# Groundwater Transfer Review Summary Form

Transfer/PA # T- 14676

Application: T-14676

Applicant Name: Jeffrey and Beth Kreder Trust

**This Interference Analysis – Proposed APOA (Well A) to LINN 4337**

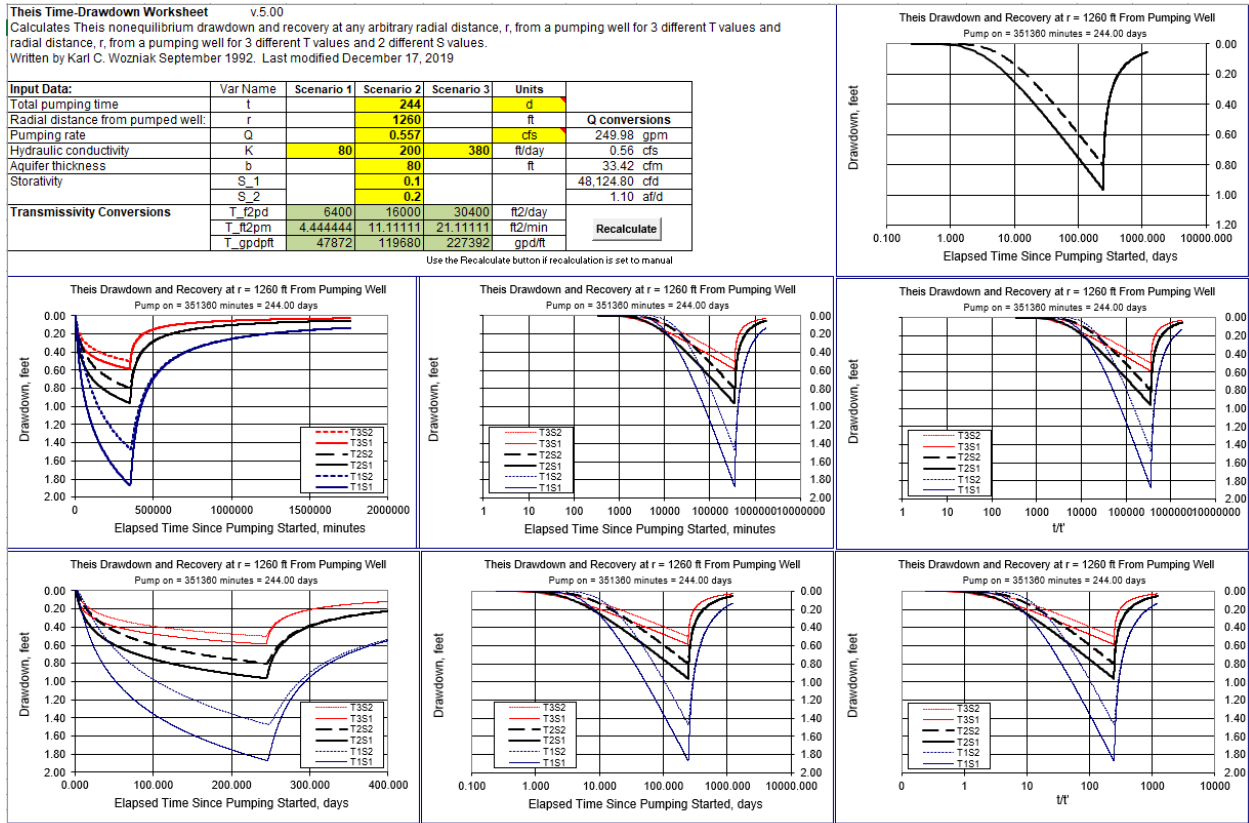
5. a) Will this proposed change, at its maximum allowed rate of use, likely result in an increase in interference with **another ground water right**?  
 Yes    No   Comments: The proposed APOA is closer than the authorized POA to LINN 4337 which is an authorized POA for claim GR-437. LINN 4337 is approximately 1,685 feet from the authorized POA (LINN 4329) and approximately 1,260 feet from the proposed APOA. The reduced intervening distance will likely result in an increase in interference.

- b) If yes, would this proposed change, at its maximum allowed rate of use, likely result in another groundwater right not receiving the water to which it is legally entitled?  
 Yes    No   If yes, explain: To assess potential injury at LINN 4337 due to the proposed change, drawdown was estimated using the Theis (1935) solution (see attached Theis drawdown analysis). Results indicate that the proposed use would likely result in less than 1 foot of drawdown at LINN 4337 which would not result in substantial or undue interference.

**Hunt 1999 Stream Depletion Model Results - Well 3/LINN 4329 with Mill Creek**

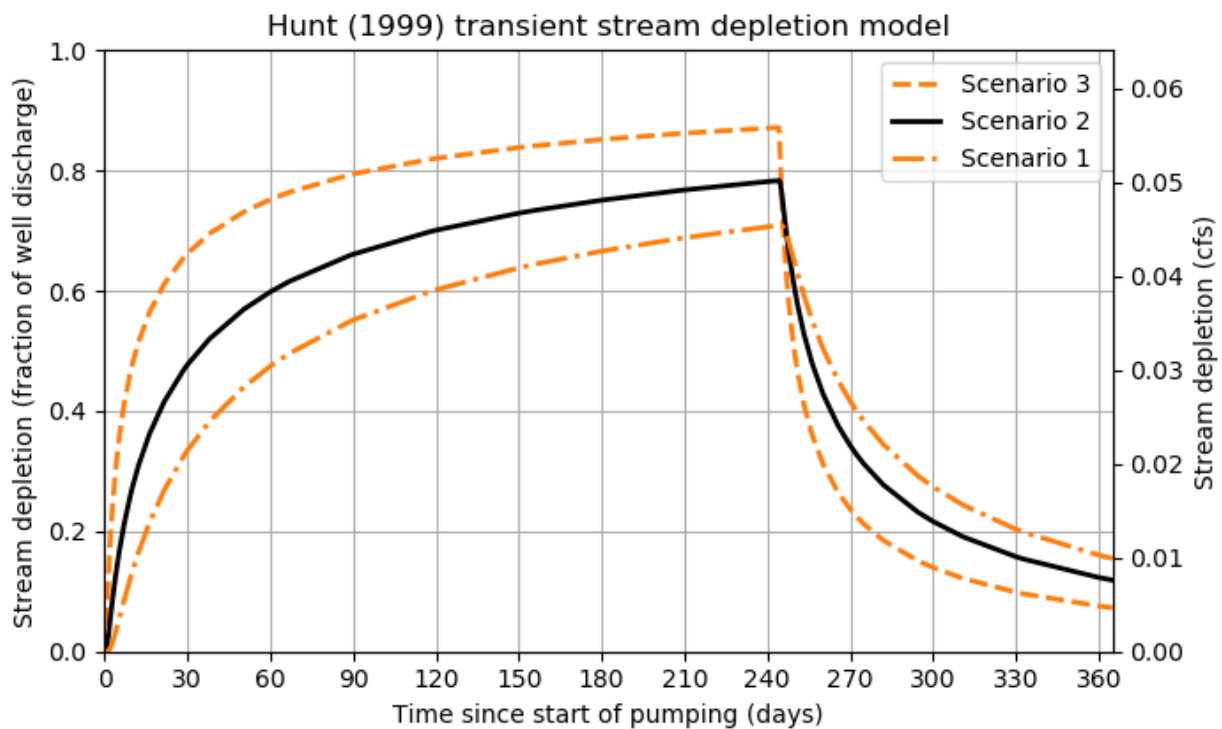
6. a) Will this proposed change, at its maximum allowed rate of use, likely result in an increase in interference with **another surface water source**?  
 Yes    No   Comments: The proposed APOA is approximately 275 feet from Mill Creek whereas the authorized POA is approximately 740 feet from Mill Creek. The reduced distance from the creek will likely result in an increase in streamflow depletion.

- b) If yes, at its maximum allowed rate of use, what is the expected change in degree of interference with any **surface water sources** resulting from the proposed change?  
Stream: Mill Creek    Minimal    Significant  
Stream: \_\_\_\_\_    Minimal    Significant  
Provide context for minimal/significant impact: The Hunt (1999) analytical model for stream depletion from pumping in an unconfined aquifer was used to estimate and compare potential impacts to Mill Creek from the currently authorized use at LINN 4329 and the proposed use at Well A. Model results indicate that, after 245 days of continuous pumping, streamflow depletion would increase by approximately 5% of the average pumping rate due to the proposed change.  
Assuming the full water duty authorized under GR-851 (30.75 acre-feet) is pumped over a 245-day irrigation season, the average withdrawal rate would be 0.064 cfs. Therefore, the proposed change would result in an additional depletion of only 0.0032 cfs to Mill Creek by the end of the irrigation season. This indicates that the proposed change would cause only a minimal increase in streamflow depletion to Mill Creek.
